WAITEMATA GREENWAYS PRE-OPENING ROAD SAFETY AUDIT

PREPARED FOR AUCKLAND TRANSPORT

20 December 2017

Figure 2 - Bus stop at 470 Richmond Road

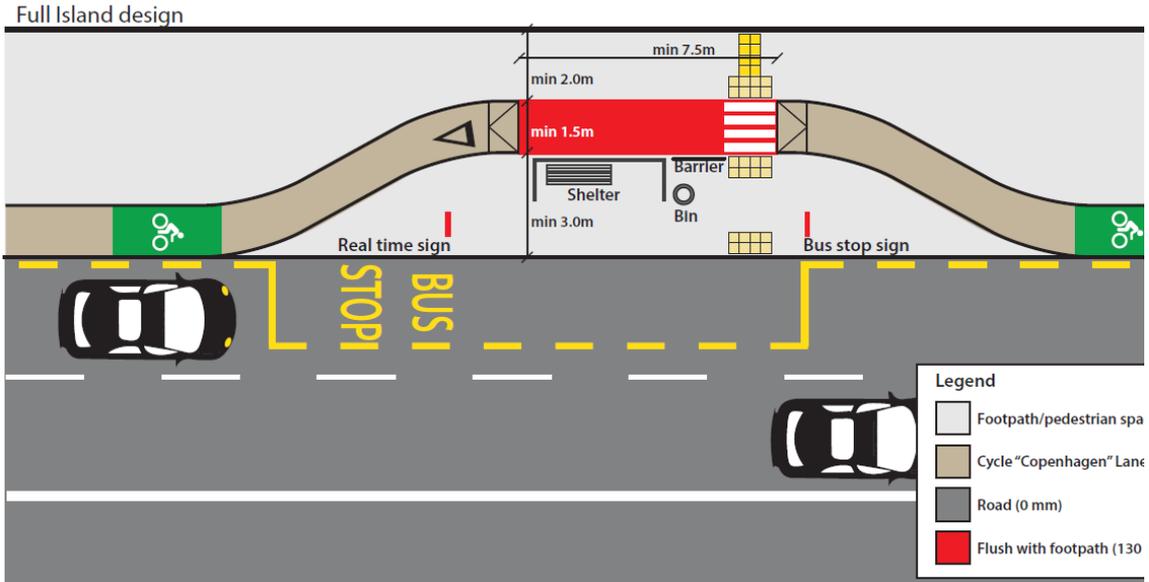
Floating bus stops are proposed at a number of locations on each route. Some of these stops have Adshel bus shelters located on the island, but not all. The safety concern is that the shelters block inter-visibility between cyclists travelling behind the shelter and a bus patron walking around the end of the shelter. This could lead to collisions between cyclists and pedestrians.

1. Reconsider the style of shelter used at the floating bus stop islands to ensure they are as transparent as possible.
2. If an Adshel is used consider placing street furniture or railings downstream from the closed end to improve the intervisibility to cyclists and redirect pedestrian movements away from the closed end
3. As per the detailed design drawings, provide a colour contrasted surface on the cycle path behind the shelter with markings and zebra bars indicating where pedestrians should cross.

Frequency Crashes are likely to be common	Severity Death or serious injury is likely	Rating The safety concern is significant
Designer response	Designer (AECOM) Response: <ul style="list-style-type: none"> - Disagree with SAT recommendation 1, Adshell shelters are required to remain along the route as per AT instruction. - Agree with SAT recommendation 2, the detailed design drawings detail (drawing C3412 sheets 1 and 2) an AT fence type E to be installed on the upstream side of the bus shelter to discourage pedestrians from crossing behind the shelter. - Agree with recommendation 3, install the cycle lane paint markings as per the latest detailed design drawings

<p>Safety Engineer comment</p>	<p>Agree with SAT comments. Floating bus stop should be consistent and the following design should be adopted.</p>  <p>Full Island design</p> <p>min 2.0m</p> <p>min 1.5m</p> <p>min 7.5m</p> <p>Shelter</p> <p>Barrier</p> <p>Bin</p> <p>Real time sign</p> <p>Bus stop sign</p> <p>Legend</p> <ul style="list-style-type: none"> Footpath/pedestrian space Cycle "Copenhagen" Lane Road (0 mm) Flush with footpath (130)
<p>Client decision</p>	<p>We agree with the installation of coloured surfacing and fencing as per SAT Comments 2 and 3.</p> <p>The floating bus stop design provided by the safety engineer does not provide further detail on the type of shelter. We note that the shelter at 474 Richmond Road is the most transparent shelter available with Adshell, AT's shelter provider.</p> <p>With the coloured surfacing and barrier, we do not believe a fully transparent shelter is required. This suggestion will be considered as the shelters reach the end of their life cycle and require replacement.</p> <p>We note that there have been floating bus stops installed where the cycling facility is not considered open for use. Coloured surfacing and barrier installation will not be implemented in these locations until the route is considered open.</p>

<p>Action taken</p>	<p>Complete coloured surfacing and Barrier installation where the dedicated cycling facility is considered complete. Bus stop locations now being reviewed by MR Cagney.</p>

Figure 19 - Island at the intersection of Baildon Road and Richmond Road

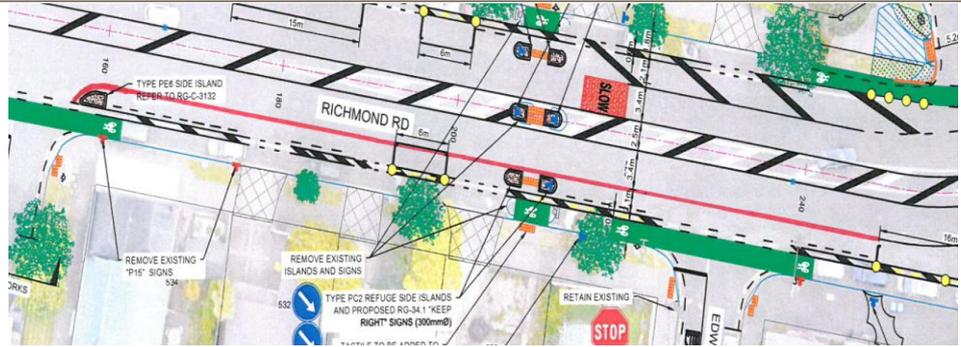
Figure 19 shows an in-lane traffic island with a flat edge facing perpendicular to approaching traffic.

The safety concern is:

- The lack of delineation lines and regulatory signage increases risk of vehicles hitting the traffic islands, especially during periods of low congestion and/or low visibility (e.g. night time, rain, fog, etc.)
- The incomplete markings misleads cyclists into using the buffer zone as a cycle way which creates a significant pinch point. In addition, riding in the buffer zone places cyclists in the door zone of the on street car parks, exposing them to a hazard.

1. Complete the proposed road markings to ensure clear delineation between cycle lane, footpath, buffer zone, parking areas and vehicle lanes (including the edge line that directs passing traffic away from this side islands).
2. Install a regulatory sign (an RG-34) on the traffic island.

Frequency Crashes are likely to be occasional	Severity Death or serious injury is unlikely	Rating The safety concern is minor
Designer response	Designer (AECOM) Response: <ul style="list-style-type: none"> - As this portion of the cycle lane is going to be a closed facility until further consultation is undertaken. We would recommend installing the edge line detailed below (in Red) in addition to the installation of the permanent regulatory RG-34 signs on the traffic island. This will ensure the traffic lane is clearly delineated through this section. - We disagree that the remainder of the proposed markings be installed as they are ineffective unless the entire design is implemented – recommend that flexi posts are installed on kerb side of island to prevent parked cars creating a pinch point

Safety Engineer comment	All traffic island within the carriageway need the correct signing. Also see 2.1.3. and 2.3.3.
Client decision	The cycle lane buffer line closest to the kerb will be removed, reducing confusion for road users. This will effectively close the cycling facility and promote Kerb side parking. Permanent signage on the island will be installed.
Action taken	Contractor to be instructed.
